ADDENDUM #1

Reference: Campground Improvements – Antelope Island State Park
Division of Parks & Recreation – Syracuse, Utah
DFCM Project No. 06138510

ADDENDUM #1
TO THE SPECIFICATIONS AND DRAWINGS
OF
Bridger Bay Campground
Antelope Island State Park, Utah

DFCM PROJECT NO: 06138510

Foundation Design - Pinned Base

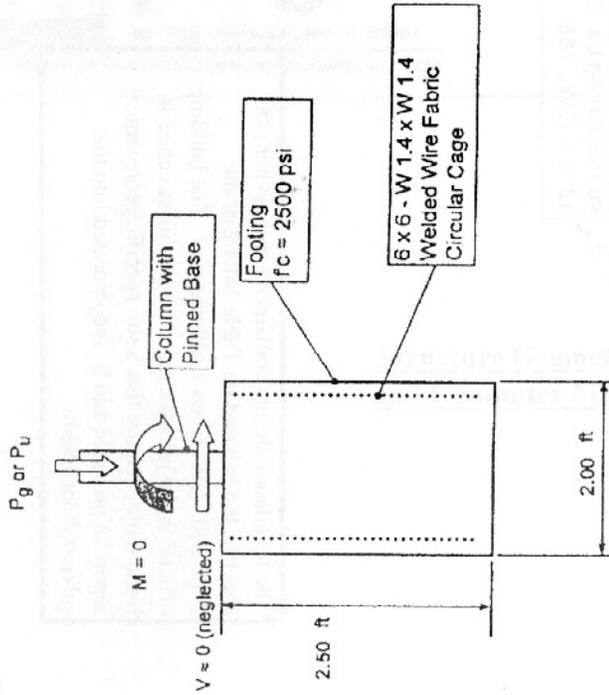
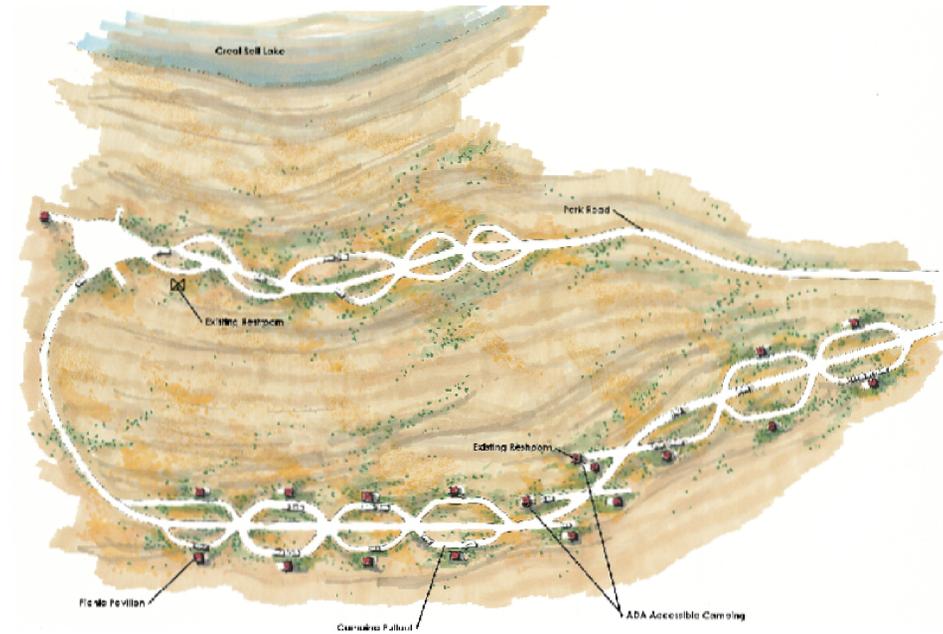
7. The pavilion slab will not be a turn down slab. Insure that soil is placed adjacent to slab edge as indicated on Detail A and C Sheet LD.01.
8. Polygon has provided a footing detail. See attached footing detail from manufacturer.
9. Polygon supplier address had been provided. See detail C Sheet LD.01

A Proposed Pavilion Pad Section
Scale: 1/4" = 1'-0"
0 2' 4" 8'

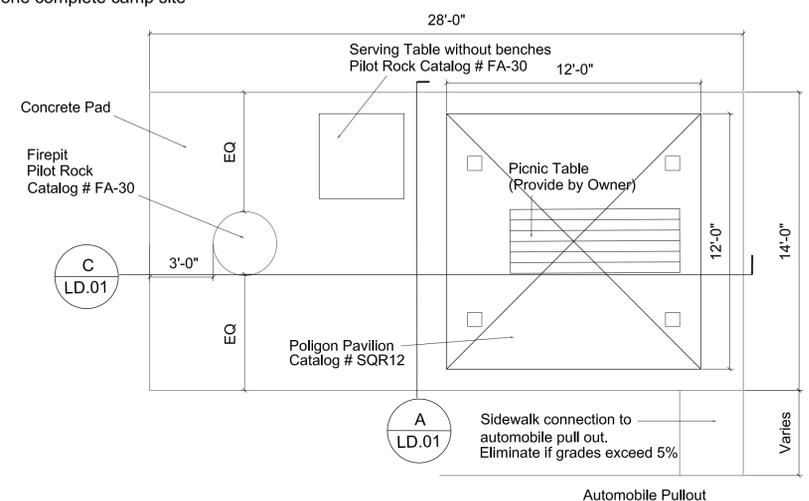
1. Disregard previous drawings and use drawings dated 6 April 2007.
2. There are to be no stairs in project. Contractor to install concrete pads as near the campsite turnout in elevation as possible so that a 5% sidewalk can connect the pad to the existing turnout. If significant excavation (more than 24") than a connecting sidewalk will not be required.
3. The project is considered remote from concrete patch plants. The specifications for concrete hauling time shall be amended to allow 90 minutes for delivery time.
4. There are ADA signs for ADA compliant campgrounds now in the drawings. See Sheet LD.01 Detail D
5. Campsite numbers have been included on the plan set dated 6 April 2007.
6. Concrete pads shall have a 2% longitudinal crown. See Detail A Sheet

LD.01.
